Addendum No. 4

Solicitation Number: *FY23-ITBCON-35*

Title: *Franklin Water Treatment Plant Clearwell Improvements*

DATE:	APRIL 2023
HAZEN NO.:	30563-027
CONTRACT NO.:	1
DRAWING NUMBER:	ED2

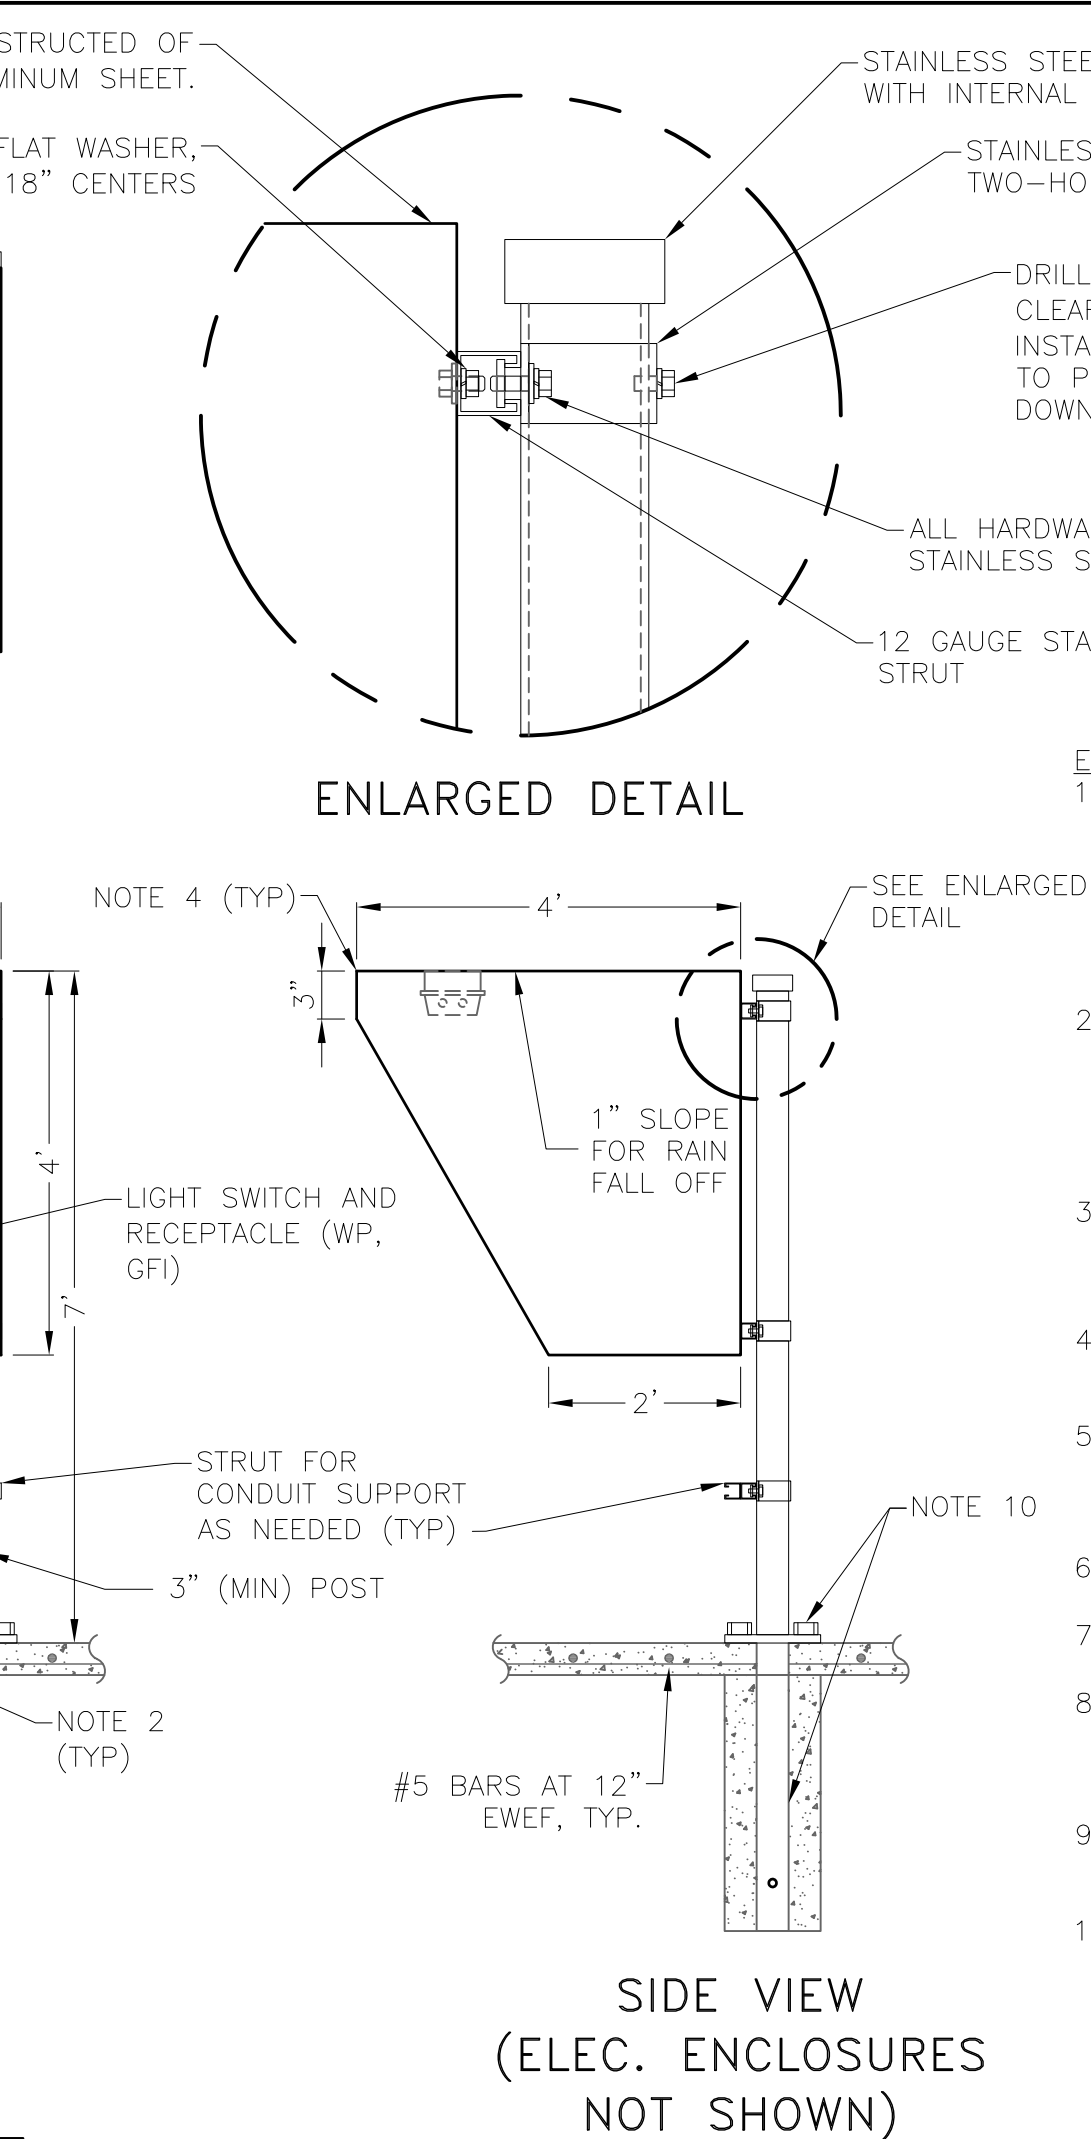
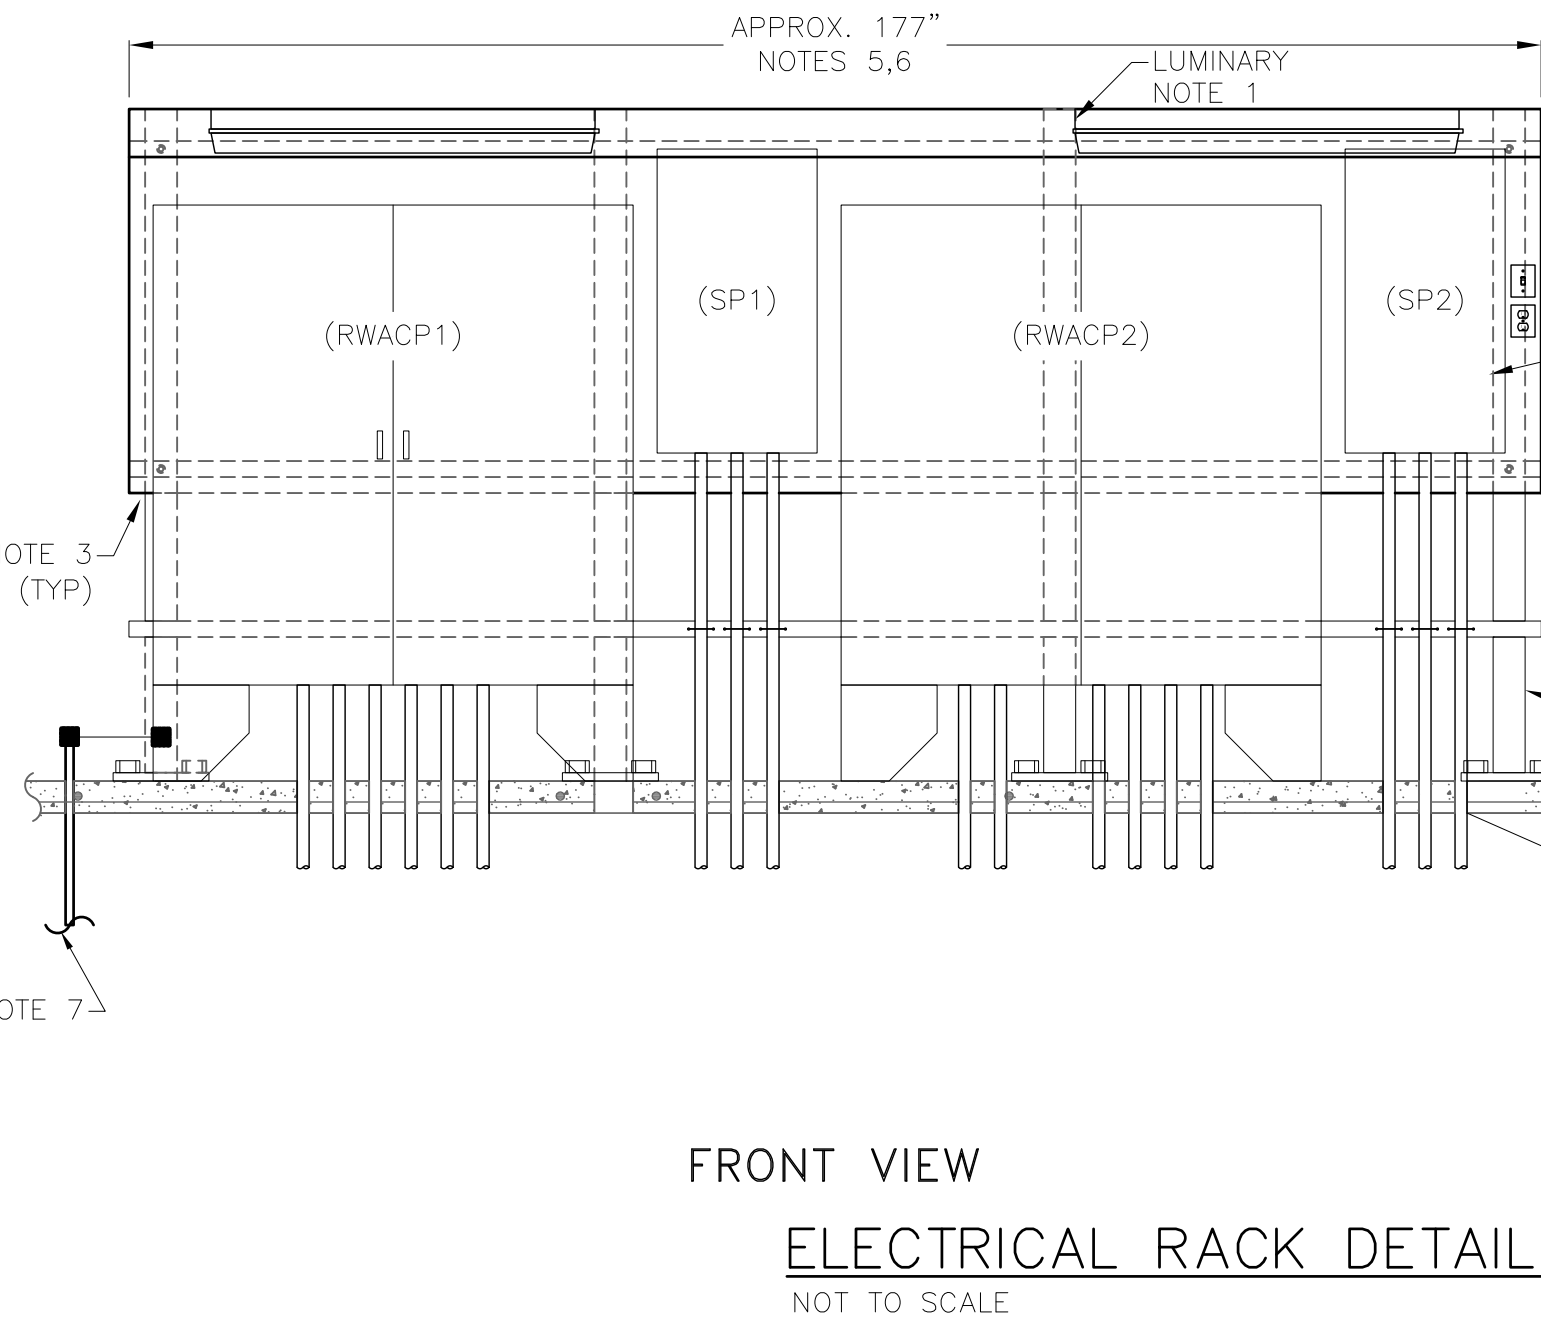
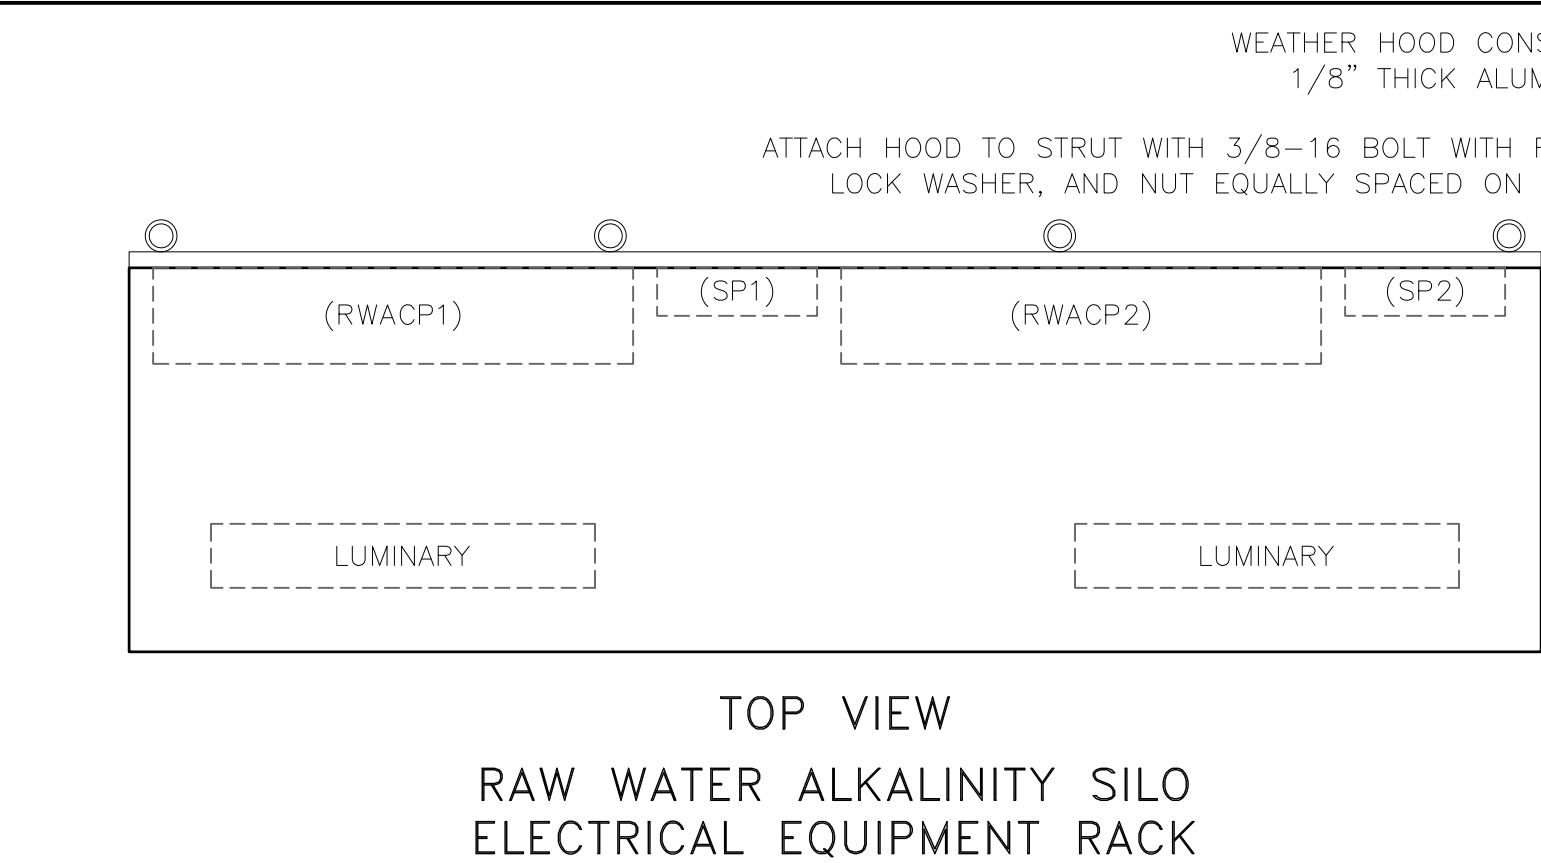
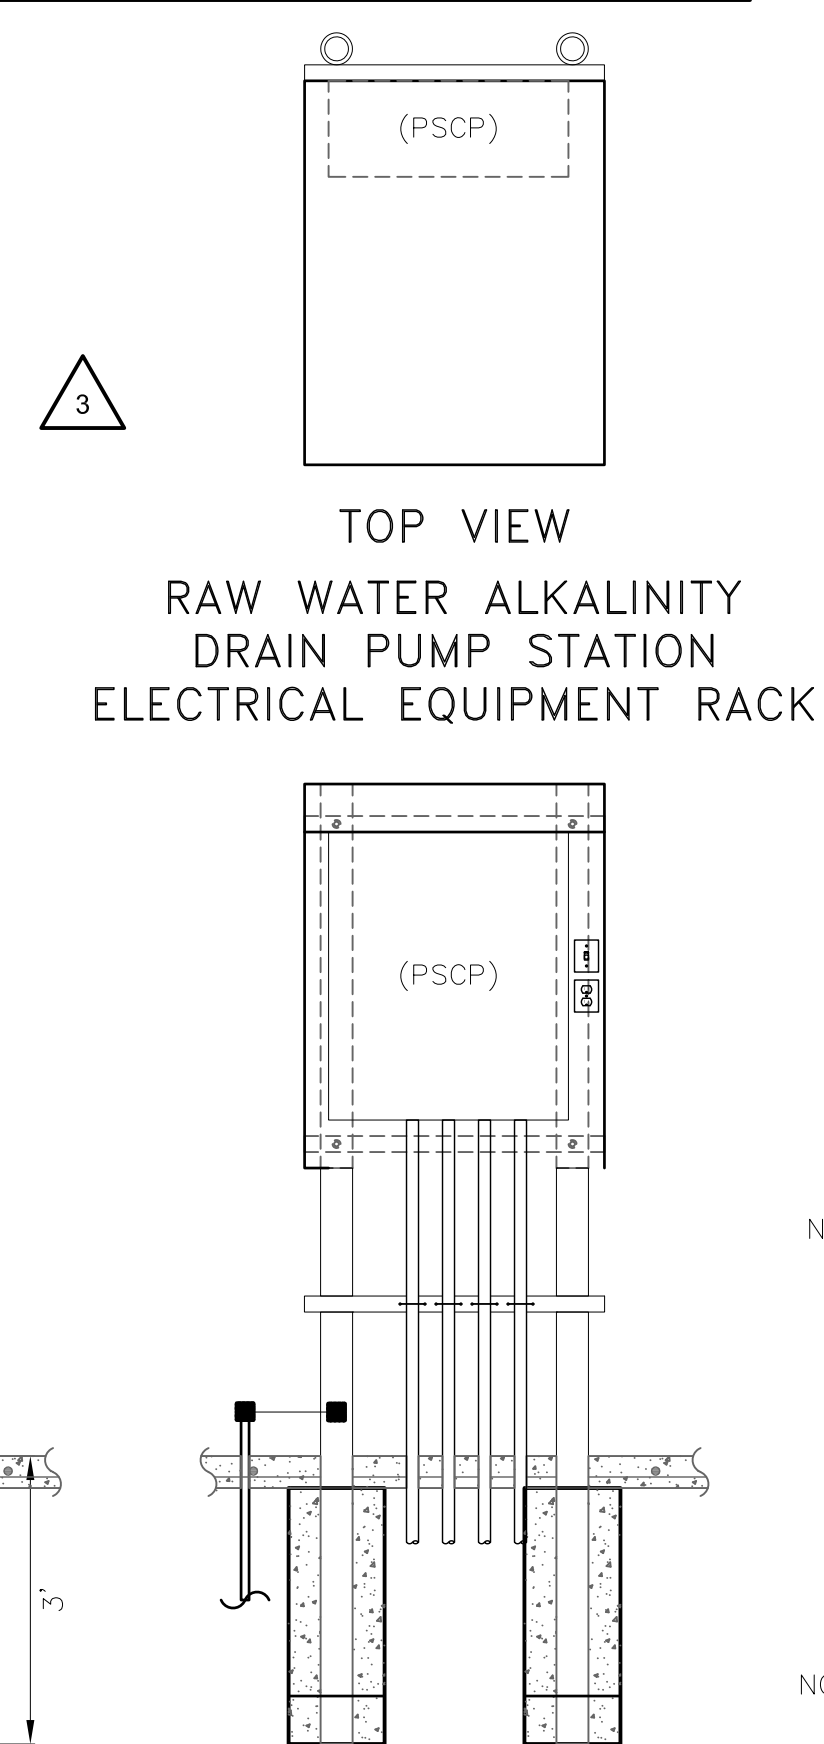
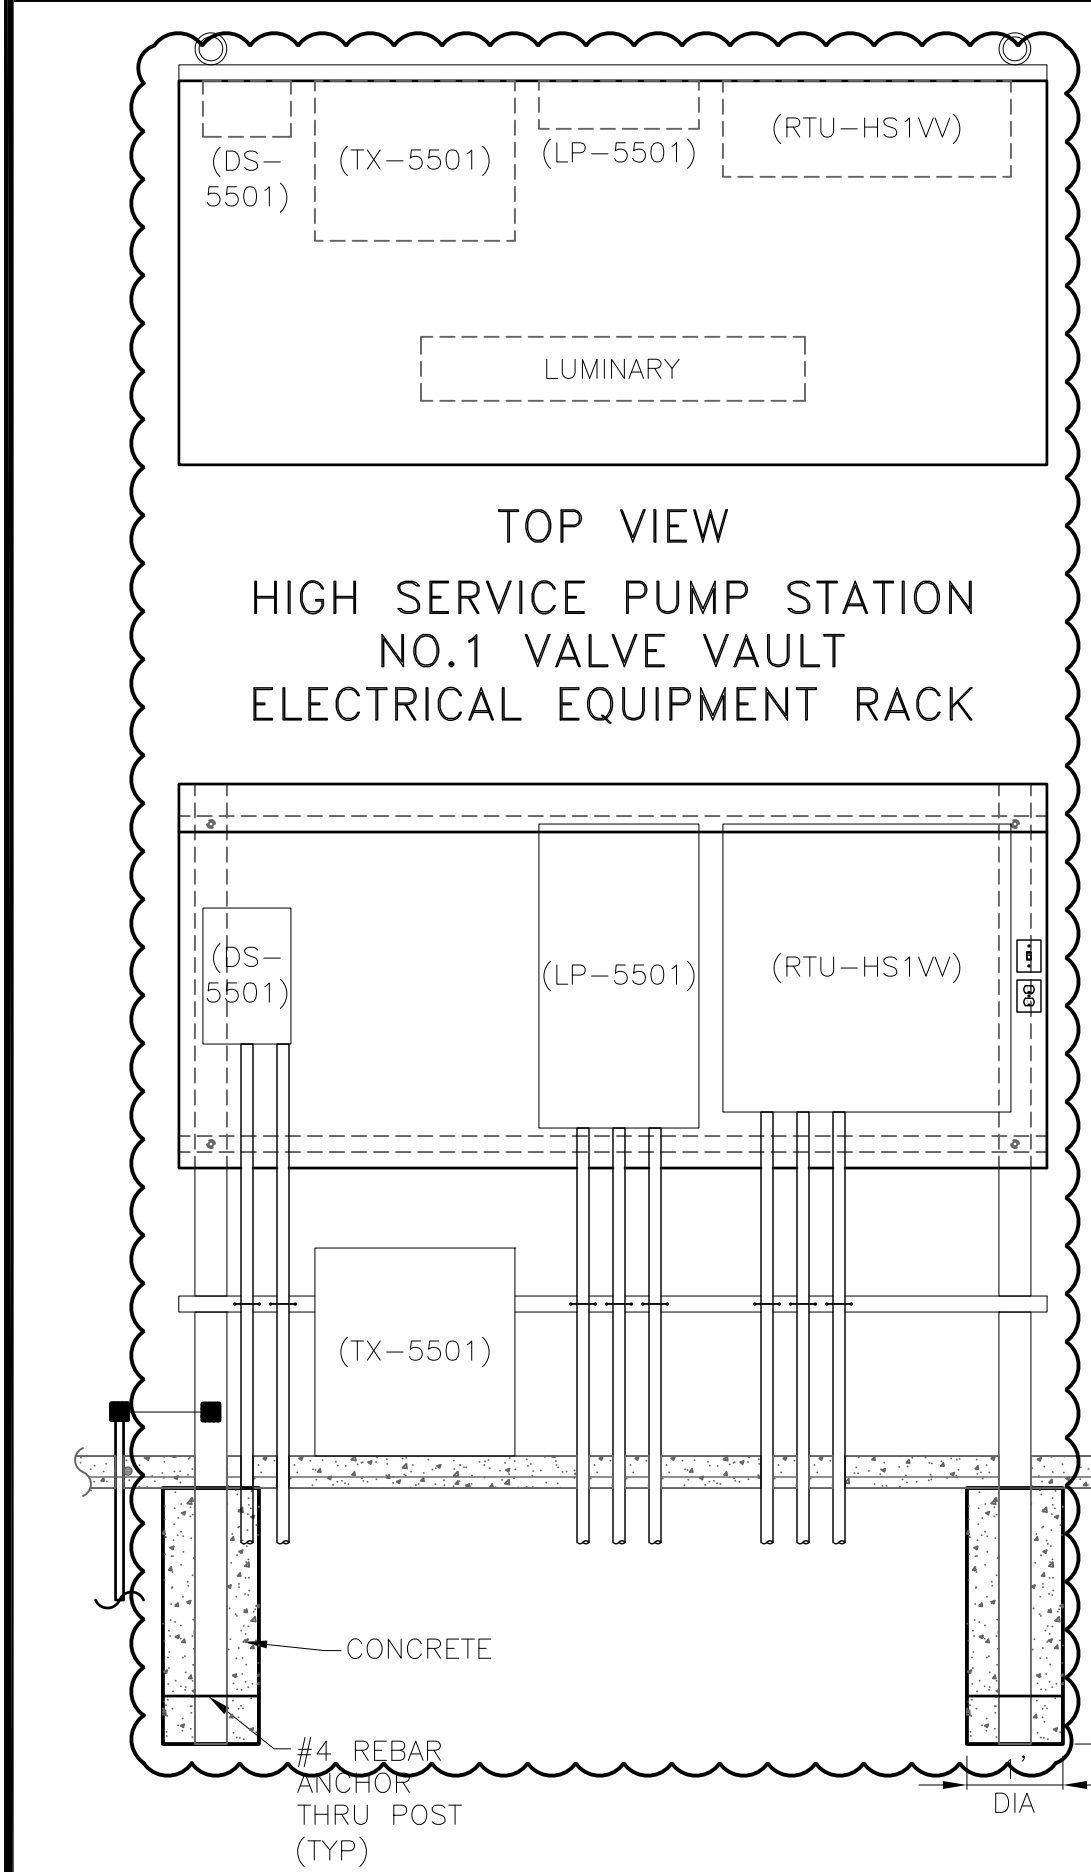
10	Contract Drawing ED2, Electrical Details	Revision No. 3	Replace Contract Drawing ED2 in its entirety with the attached revised Contract Drawing ED2. It has been revised to show names of equipment in the Electrical Rack Detail. An Electrical Handhole Detail has also been added.
